Our Case Number: ABP-313892-22

Re: Bus Connects Blanchardstown to City Centre Core Bus Corridor Scheme

LDG- ABP-
	1 2 JUL 2023
Connecting Cabra CBC05 Bu	SConnects Time: 12130 By: How
Response (Case: 3138	92)

Chapter 4.18.2

Figure 1 Above: Schematic showing Annamoe Rd & Annamoe Terrace Junction. Below: Measurement from Google Maps showing 7.26m wide for a single carriageway on Annamoe Rd

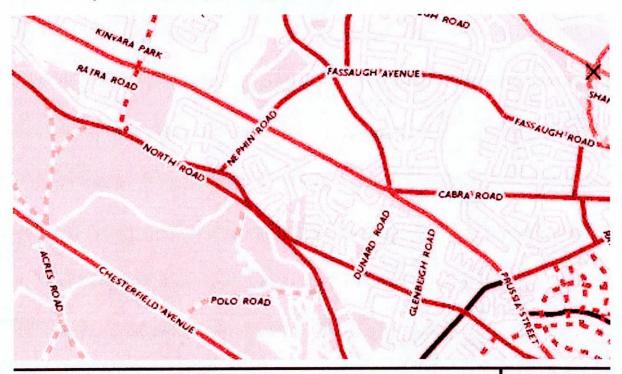
1.0 Annamoe Rd & Annamoe Terrace Junction

The Annamoe Rd & Annamoe Terrace Junction (as shown in Figure 1) is dangerously wide for two local roads. The width Annamoe Rd itself is 8.5m. The width of one carriageway on Annamoe Rd at this junction is 7.26m (Displayed in Figure 1). It is far too large for a local road. The proposed junction design violates several DMURS and BusConnects own design requirements.

- Chapter 04 of the application "Proposed Scheme Description" Section 5.1 Traffic Lane
 Width states: "Traffic lane widths will follow the guidance outlined in DMURS"
- Carriageway widths as per DMURS Section 4.4.1 Carriageway Widths: "The standard carriageway width on Local streets should be between 5-5.5m (i.e. with lane widths of 2.5-2.75m)."
- DMURS Section 4.3.3 Corner Radii: "Where design speeds are low and movements by larger vehicles are infrequent, such as on Local streets, a maximum corner radii of 1-3m should be applied.
- DMURS Section 4.4.3 Junction Design: "Omit staggered crossings in favour of direct/single phase crossings (see Section 4.3.2 Pedestrian Crossings)."

This junction should build out the existing footpath kerb to the pedestrian island. The current width of the carriageway here is 7.26m at its narrowest (as shown in Figure 1). This carriageway should be the new two way ingress and egress for vehicular traffic.

Finally, there should also be an at grade pedestrian "courtesy crossing" as this is the primary crossing point for pedestrians to the shops on Annamoe Terrace, which is a focal point in the community as per **DMURS Section 4.3.2 Pedestrian Crossings:**
